Access Compliance Report

Public Rights-of-Way

Intersection ID: 6787	Main Street: N_GRAHAM_ST	Cross Street: PRINCESS_ST	Location: E
ADA ID: 23F8BB15B4FF	Ramp Type: Perp	Initial Pass/Fail: Fail	Overall Compliance: No
Severity Score: 21.25			
Codes/Mitigation Info/Possible Solution		Field Measurements/Component Compliance

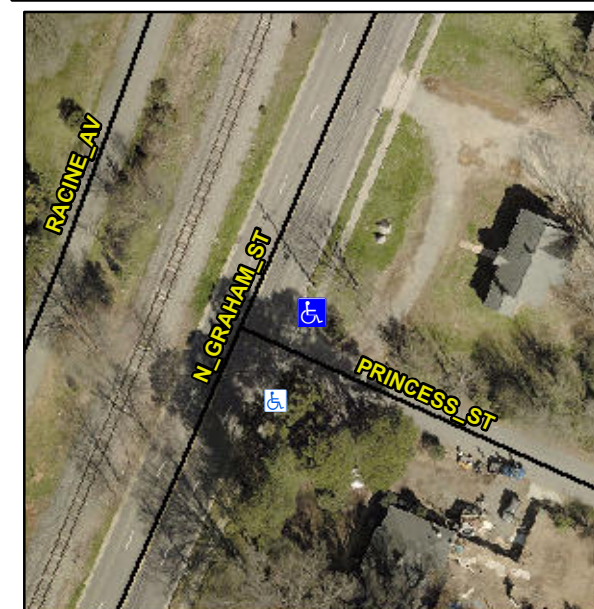
Not Found, R304.5.1, R304.2.2

Compliance	Description	Data	Compliance	Description	Data
N/A	Ramp Length (in)	41.0	No	Ramp Slope (%)	8.4
No	Ramp Width (in)	43.5	Yes	Ramp XSlope (%)	0.5
N/A	Flare Type LT	N/A	N/A	Flare Type RT	N/A
N/A	Flare Slope LT (%)	N/A	N/A	Flare Slope RT (%)	N/A
N/A	Flare Traversable LT?	N/A	N/A	Flare Traversable RT?	N/A
N/A	Landing Length (in)	N/A	N/A	DWS Provided?	N/A
N/A	Landing Width (in)	N/A	N/A	DWS Contrast?	N/A
N/A	Landing Slope (%)	N/A	N/A	DWS Length (in)	N/A
N/A	Landing X Slope (%)	N/A	N/A	DWS Full Width?	N/A
N/A	Landing Curb? (Y/N)	N/A	N/A	DWS Offset (in)	N/A
N/A	Shared Landing?	N/A			
N/A	Gutter Ponding?	Yes	N/A	Gutter Slope (%)	N/A
N/A	Gutter Lip Ht (in)	N/A	N/A	Gutter X Slope (%)	N/A
N/A	Painted X Walk1?	No	N/A	Painted X Walk2?	N/A
	X Walk 1 Direction	To SW		X Walk 2 Direction	N/A
N/A	X Walk 1 Width (in)	N/A	N/A	X Walk 2 Width (in)	N/A
	X Walk 1 Slope (%)	1.9		X Walk 2 Slope (%)	N/A
	X Walk 1 X Slope (%)	1.5		X Walk 2 X Slope (%)	N/A

Remove & Replace Entire Ramp.
